CONDITIONS OF APPROVAL:

Engineering - Final Plat Checklist

FINAL SUBDIVISION PLAT

FRANKLIN, WILLIAMSON COUNTY, TENNESSEE

9. C. Final Plat

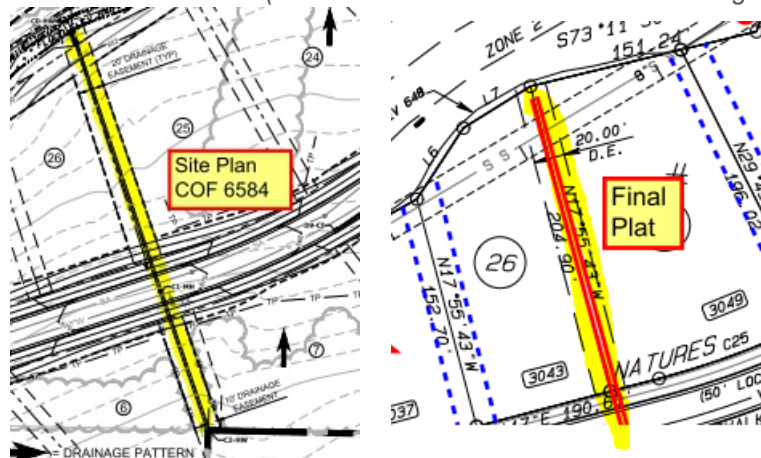
lance.fittro@franklin.tn.gov The existing home on the property noted to be removed must be removed prior to final approval of the plat at One Stop and subsequent recording.

10. 0. General Information

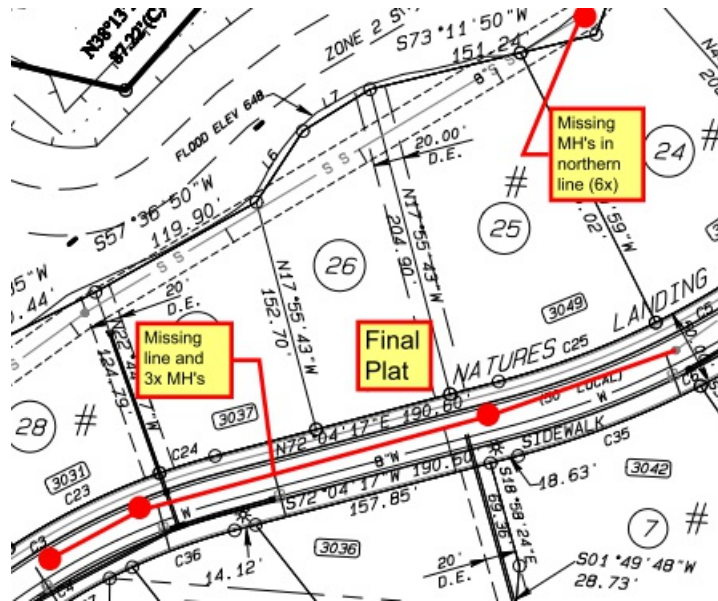
joe.marlo@franklin.tn.gov Comment not adequately addressed. Final plat to match Site Plan (COF 6584).

1. Addressed
2. Addressed
3. Storm Infrastructure (Show storm infrastructure in easement highlighted)

4. Show sanitary sewer infrastructure matching Site Plan, including that in Natures Landing Drive, and manholes in the sewer line along the rear of the northern lots.

5. Label Zone 1 Stream Buffer south of stream (Shown on previous submittal but removed from current submittal).

Applicant shall ensure that any modifications to the site plan (COF 6584), which is being reviewed concurrently with this final plat, are reflected on the final plat. The final plat shall match the site plan, including the following:

13. Final Plat Graphics and Text

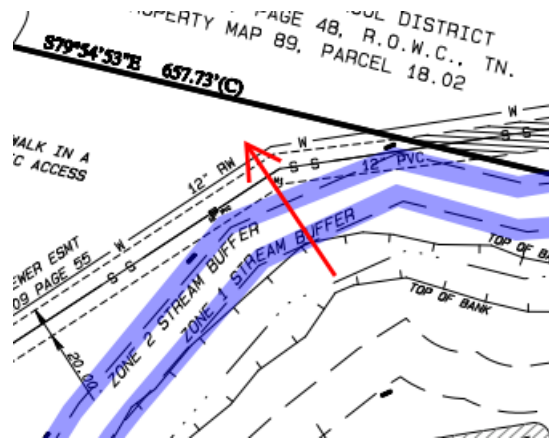
1. Addressed
2. Addressed
3. Stream buffers now shown to the north of stream appear to have been dimensioned from the centerline of stream instead of the top of bank. Buffers are to be shifted to be dimensioned from top of bank.

4. Remove symbol shown on Lot 5. This lot is not shown as a critical tree on the Site Plan.

Applicant to revise the following information regarding graphics and text on the plat:

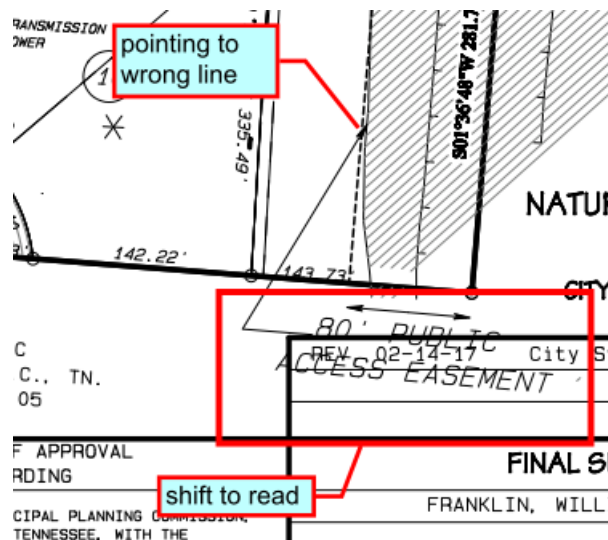
4. Addressed.
5. Change all "PUDE" labels on Open Space Lots 134 and 136 to "PUADE", matching Note 2 in IDT Comment #19 (4 places on plat).

6. Shift the All Public Access Easement to read. Revise leader to point to access easement line (and not FWO/FFO line).

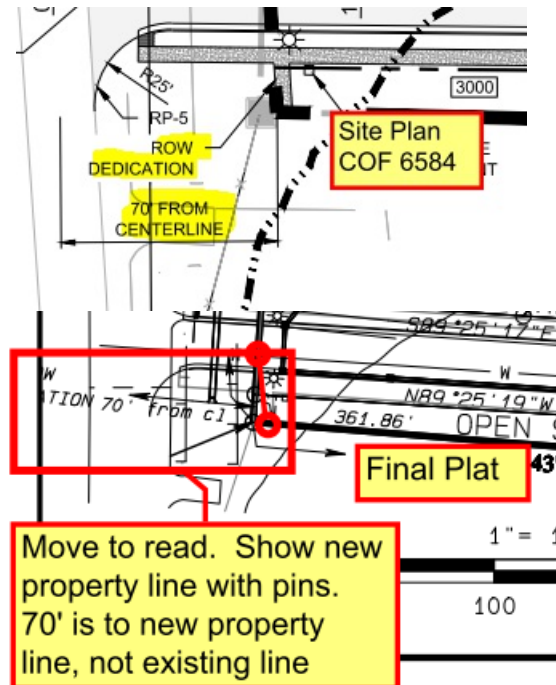
8. Change the D.E. assignments that were changed from the previous submittal back to PUDE, typical 4 places.

18. Flood Information

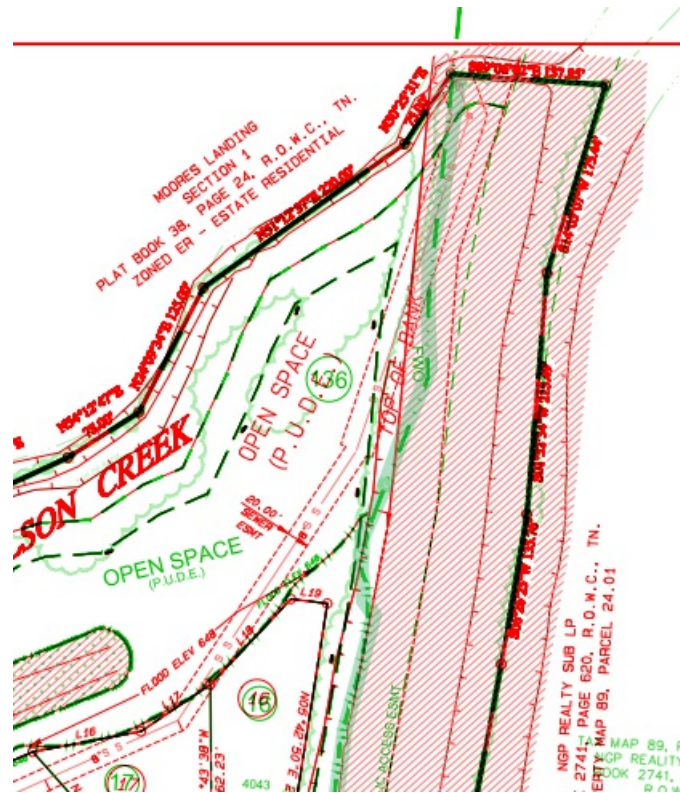
joe.marlo@franklin.tn.gov Flood information now shown on the plat does not appear to match the Site Plan in the northeast corner of the site.

Applicant to verify the flood information shown on the plat with that shown the Site Plan. See overlay below with the Site Plan (COF 6584) in Green, and the Final Plat in Red.

24. Sidewalk

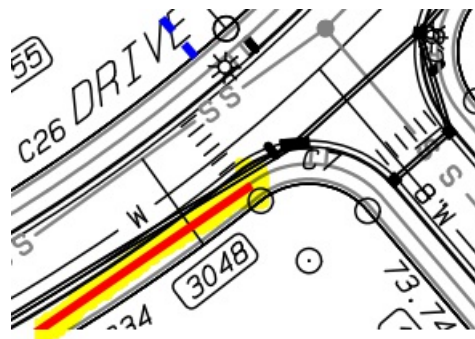
joe.marlo@franklin.tn.gov Comment not adequately addressed. Sidewalk line still missing.

Applicant to show a sidewalk on the south side of Natures Landing Drive, as shown on the associated Site Plan.

SHEET 2 OF 2

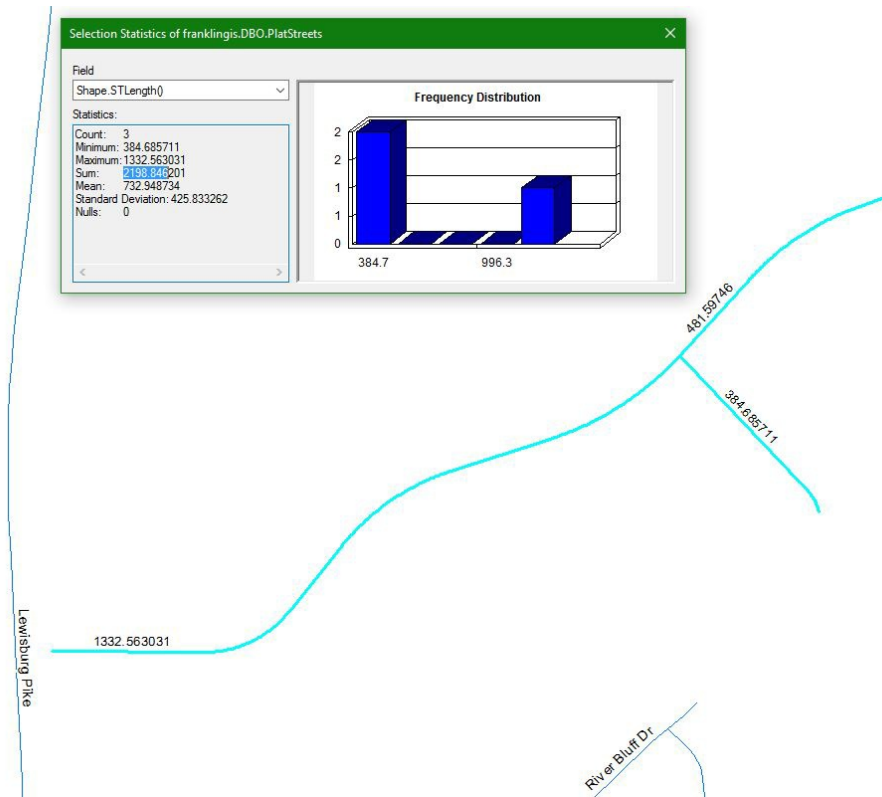
jake.harvey@franklin.tn.gov Total new street length 2,198.85ft. Total new street length as it appears on the final plat is 3,303ft.

The Final Plat needs to match GIS street centerline total.
